TOWN OF TIBURON
Tiburon Town Hall
1505 Tiburon Boulevard
Tiburon, CA 94920

Regular Meeting
Design Review Board
May 5, 2016
7:00 p.m.

AGENDA
TIBURON DESIGN REVIEW BOARD

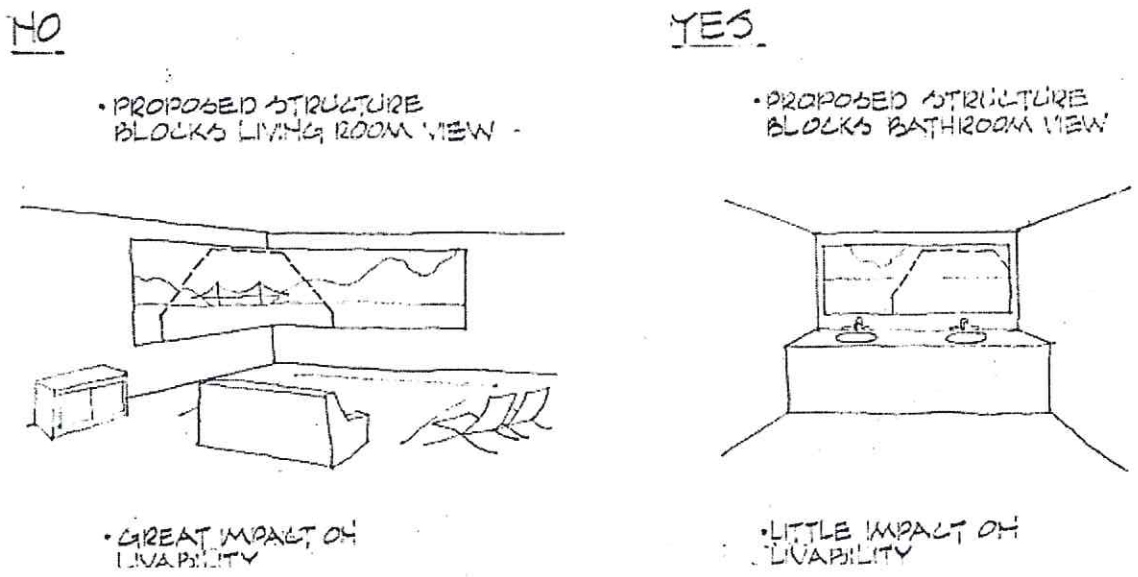
The second story would substantially increase the height of the building. The existing house is relatively short, with a height of only 10 feet, 6 inches. The second story would increase the

building height by 16 feet, 8 inches to a height of 27 feet, 2 inches. This proposed building height appears to be somewhat tall for a two-story home built on a relatively flat building site.

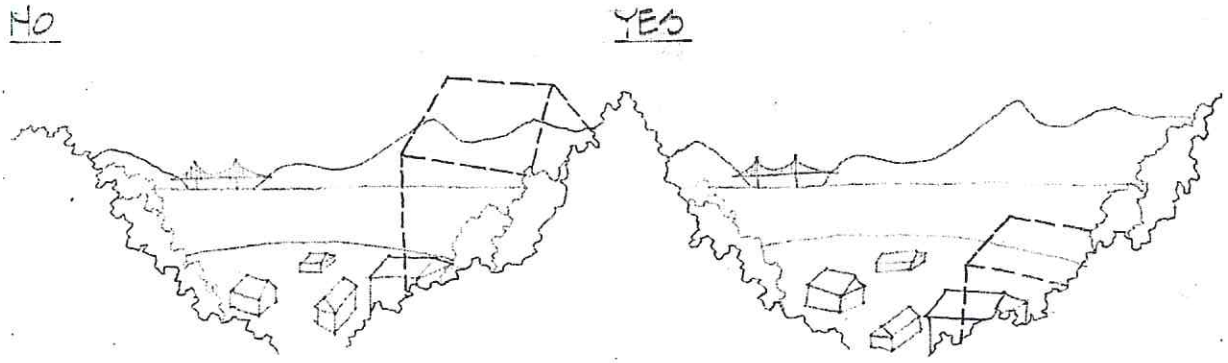
> Goal 3, Principle 7 (B) of the Hillside Design Guidelines states that "horizon line is [the] most sensitive part of [a] view, then foreground, then middleground. If possible, avoid

cutting [the] horizon line of a neighbor's view." The proposed raised roofline would cut into the horizon line of San Francisco from several bedrooms of the home at 16 Acela Drive, and would extend into the foreground views of the home at 14 Acela Drive.

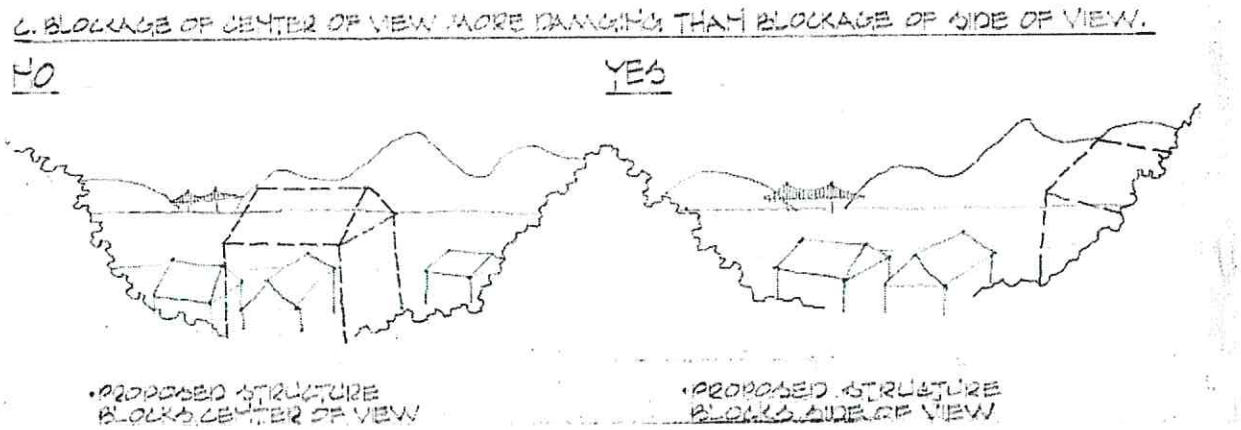
Goal 3, Principle 7 (C) of the Hillside Design Guidelines states that "blockage of center of [the] view [are] more damaging than blockage of [the] side of [the] view." The second story would intrude into the center of the view from the home at 14 Acela Drive and the side of the views from the home at 16 Acela Drive.

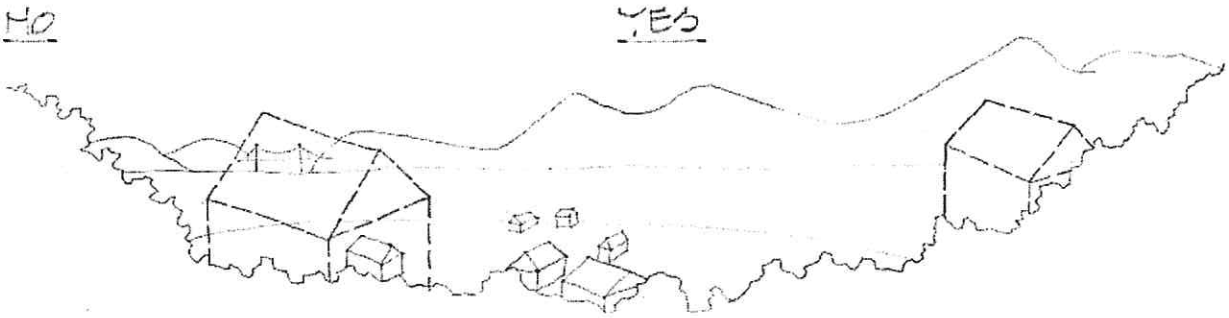
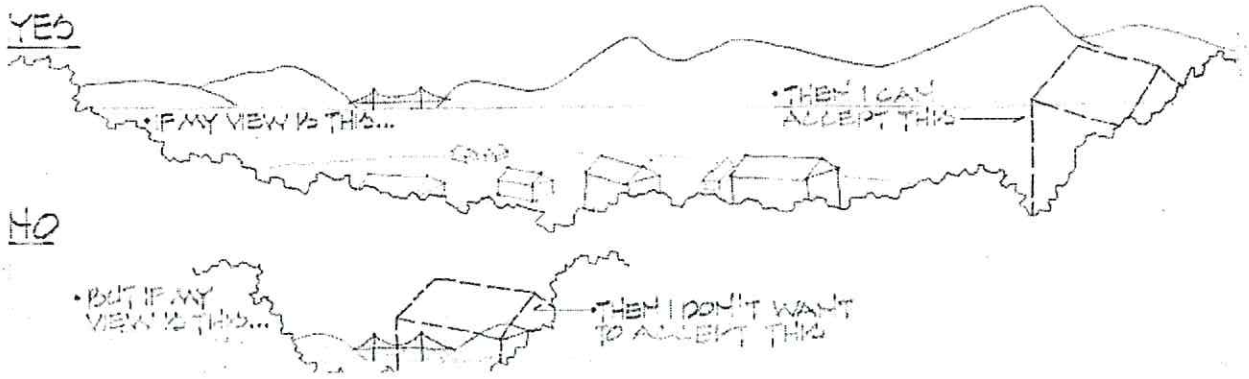
Goal 3, Principle 7 (D) of the Hillside Design Guidelines states that "blockage of important object in the view (Golden Gate Bridge, Belvedere Lagoon, Sausalito, Angel Island) is more difficult to accept than blockage of other, less well-known landmarks." The second story would block almost all views of the Belvedere Lagoon from the living room and adjacent deck of the home at 14 Acela Drive. The second story would intrude into Golden Gate Bridge views from one bedroom and eliminate downtown San Francisco views from another bedroom of the home at 16 Acela Drive.

Goal 3, Principle 7 (E) of the Hillside Design Guidelines states that "a wide panoramic view can accept more view blockage than the smaller slot view." Both homes at 14 & 16 Acela Drive have relatively panoramic views that run from San Francisco to Mt. Tamalpais.
